SUBJECT: Revised map for Depper

Attached is the revised sampling plan previously submitted to you. After review of your revisions, I concur with the changes and have verified it by labeling the attached map. I understand that the two (2) soil samples to be collected from each borehole will be taken from the 3 foot bgs level and from the capillary fringe. We may collect soil samples from below the capillary fringe, in addition to those identified in the sampling plan, to establish the vertical depth of contamination in soil.

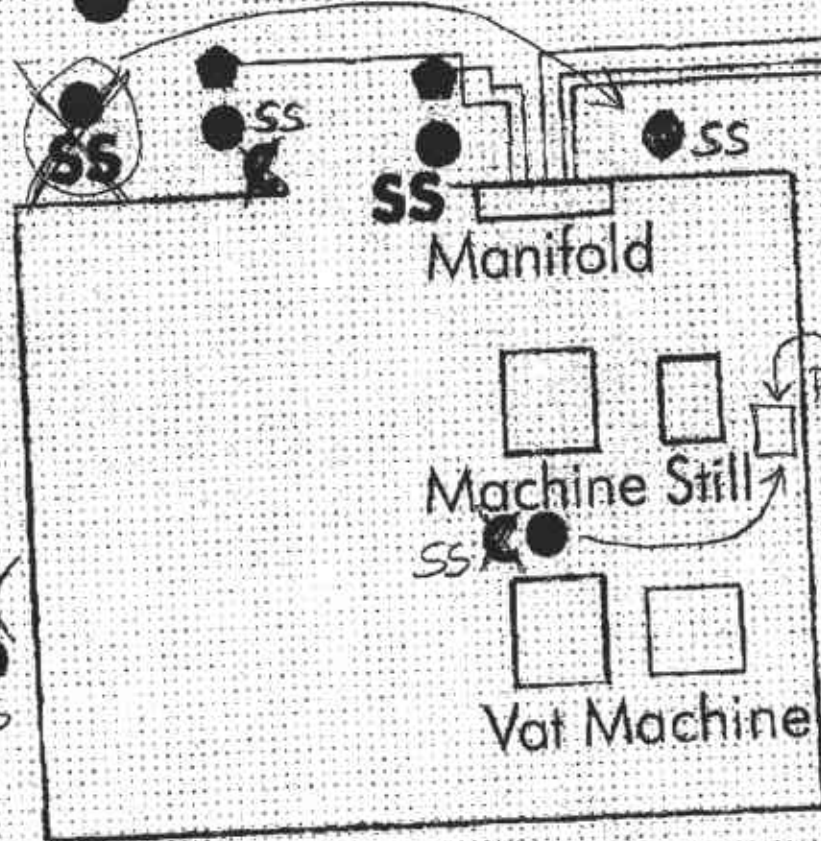
Change C to SS (3)
 added SS to C (4)
 moved one SS (1)
